Response to Submissions Report

SSD-62802207

**Showground Station Precinct East
3 Andalusian Way, Castle Hill**

Figure 1: Proposed redistribution of building height (Source: Turner Studio)

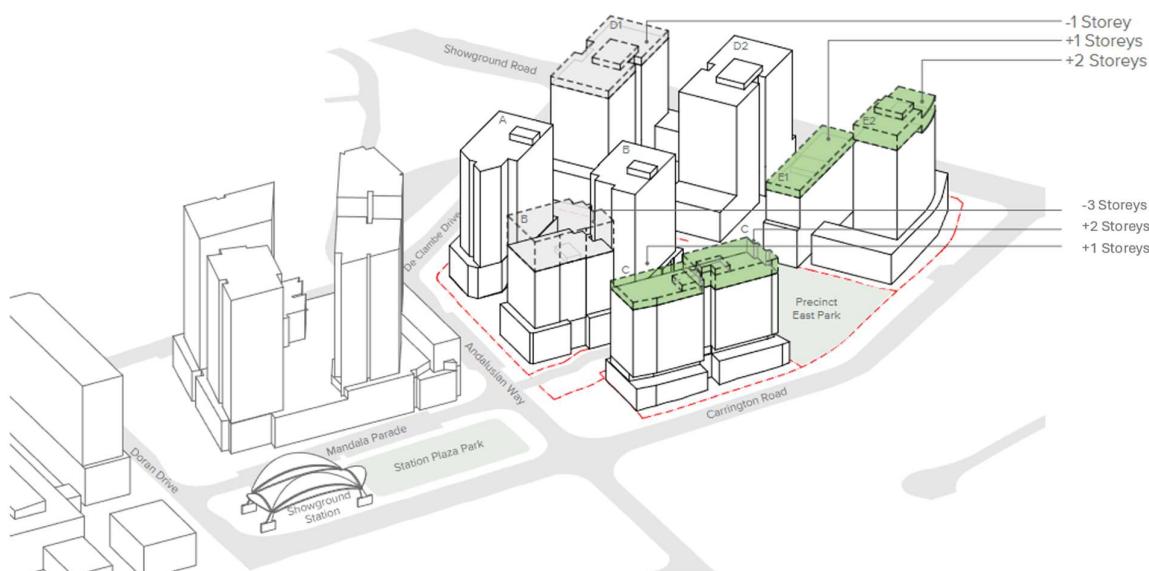
“It is understood that there is limited scope to amend the approved Concept Plan. However, it is noted that the precinct would benefit from greater variation in building heights. Explore the potential to reduce the height of the north of the site and add more height to the south to improve amenity, particularly increased solar access.”

Following discussion with DPE and SDRP, to achieve solar compliance to the Precinct East Park and the Station Plaza as required by the UDG whilst maintaining compliance with the desired density envisaged for the Precinct, building heights have been redistributed across the site.

Figure 1 identifies the areas which have been reduced in height in grey and the areas which have increased in height in green.

Not only does the amended built form massing improve solar access, but the height redistribution has introduced height variation not only within the buildings, but across the Precinct. It is noted that greater height variation within the Precinct was requested by the SDRP at the initial meeting held on 1st November 2023.

The additional height has been purposefully located to the south of the Precinct to improve amenity and improve solar access to public and private open spaces. The redistributed height responds to the planning controls and likely future form of development in the broader Hills Showground precinct on the southern side of Carrington Road. This includes promoting a consistent height and form along Carrington Road and ensuring future development is capable of meeting ADG requirements.

Figure 3: Plan of window screen locations on towers D2 and E2 which protrude beyond the approved envelope by approximately 250mm (Source: Turner Studio)

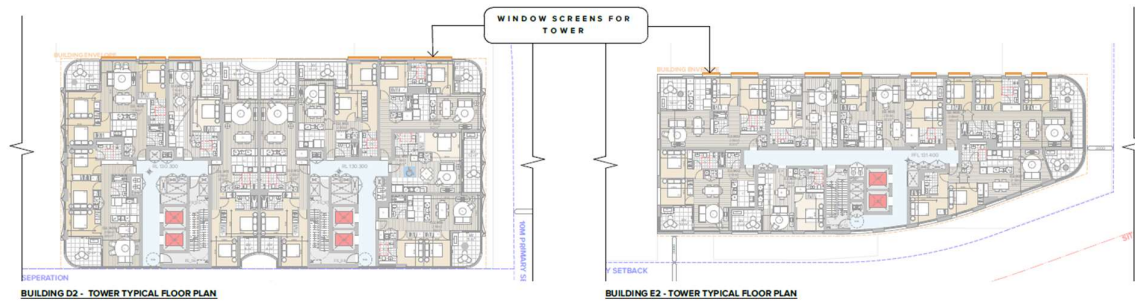
- c. Notwithstanding the proposed modifications seeking height variation, amend the proposal to remove protrusions outside the approved building envelopes.

The only exception relates to the introduction of awnings and solar shading louvres which have been added to respond to the SDRP's comment that effective sun shading should be provided to reduce summer heat gain and improve energy performance. The protrusions for solar shading elements are minor (varying between 250mm and 150mm) and are limited to the northern extents of the B1, B2, D2 and E2 towers (refer to **Figure 3, Figure 4 & Figure 5**).

Figure 13: Amended SSDA scheme showing revised typical layout of Building E1 upper level (Source: Turner Studio)

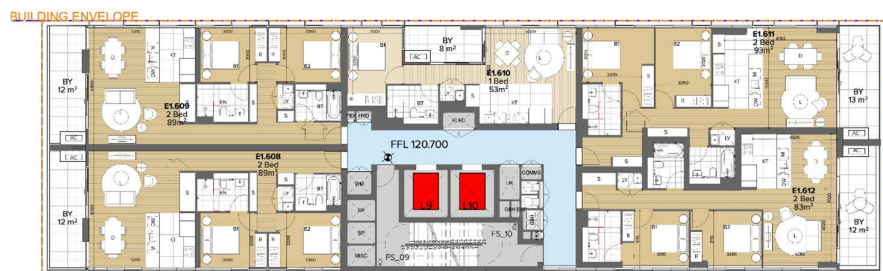
In response to DPE and SDRP comments, improvements have been made to reduce reliance on horizontal plenums and increase apartments achieving natural cross ventilation and amend apartment layouts to maximise solar access to living rooms. This comment was focused on Buildings D2 and E1.

Refer to the figures below demonstrating the amendments to the layout in the Building E1 upper levels to improve residential amenity.

Figure 15: Amended SSDA scheme showing removal of lower ground floor basement underneath the publicly accessible pedestrian link

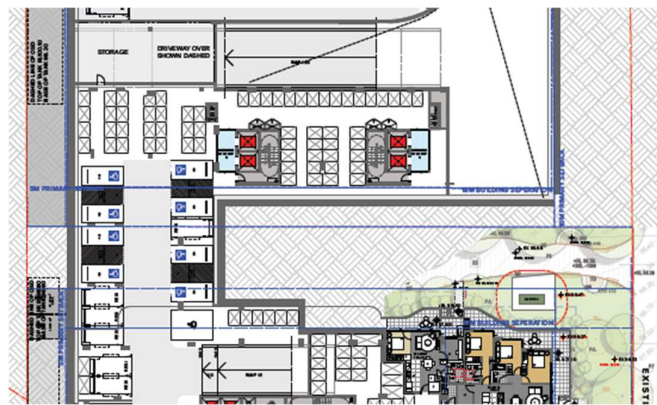
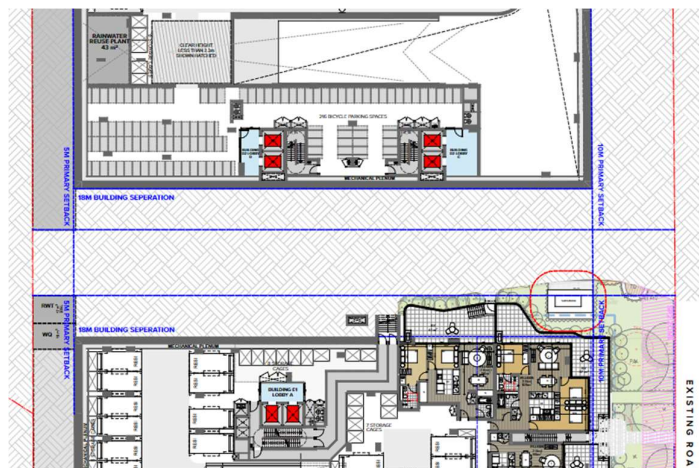
- maximum number of storeys
- primary and secondary setbacks
- maximum building facade lengths and articulation requirements
- no basements permitted beneath the new pedestrian link
- deep soil planting and canopy coverage.

In response to DPE and SDRP comments, the extent of the basement located underneath the publicly accessible pedestrian link has been rationalised. The lodged scheme included a connection at lower ground level along the western extent of the link (refer **Figure 14**).

The amended scheme does not include any basement at lower ground level and instead provides for a minimum 2m set down of the basement slab underneath along the site link's full extent to provide for significant soil depth sufficient for large tree types and quality soft landscaping, refer **Figure 15**. The set down allows for a flush condition within the public domain, free of mounding and retaining walls and results in a more open and permeable streetscape.

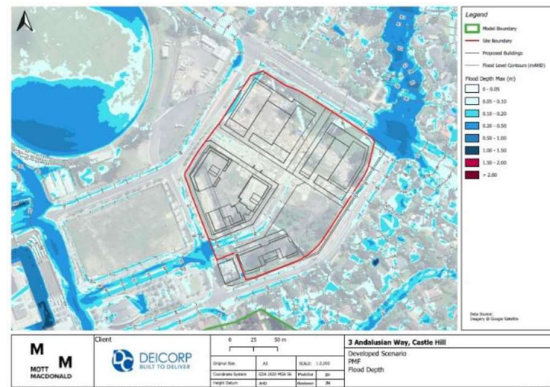
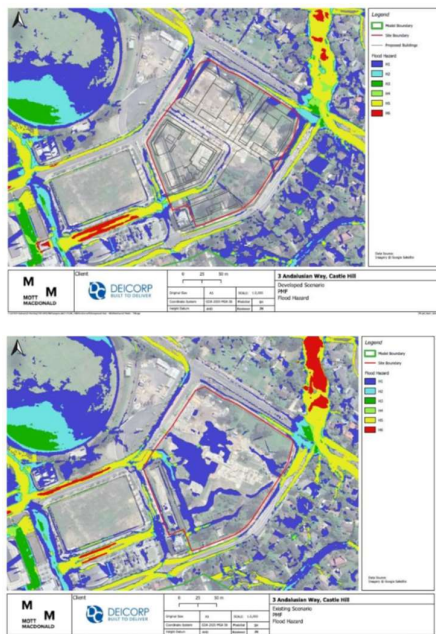
The flood depth modelling results provided in the Flood Impact Assessment is inconsistent.

The proponent has provided flood depth and hazard information for the 1% AEP and PMF pre and post development scenarios. The afflux maps provided in Appendix D appear to show an increase in flooding of 300mm to 500mm throughout the site (Figure 1 below), however this does not appear to be present in the developed scenario results provided (Figure 2 below).

The figures need to be corrected and resubmitted to BCS for review. It is important to note that that flood damage occurs from very low depths of floodwater. The impacts are shown as 30mm – 50mm. The precise increases at any affected entry point should be stated and mitigation measures should be considered where appropriate to address excessive increases to flood depths.

The flood depth and hazard increases to Mandala Parade east of the site is unacceptable.

Based on the figures provided, the post development scenario significantly increases the flood depths and hazard on Mandala Parade (Figure 3 vs Figure 4). Ministerial direction 4.1(3) requires that the proponent must not increase flood risk to other properties or significantly increase the requirement for government spending on emergency management services, emergency response measures.
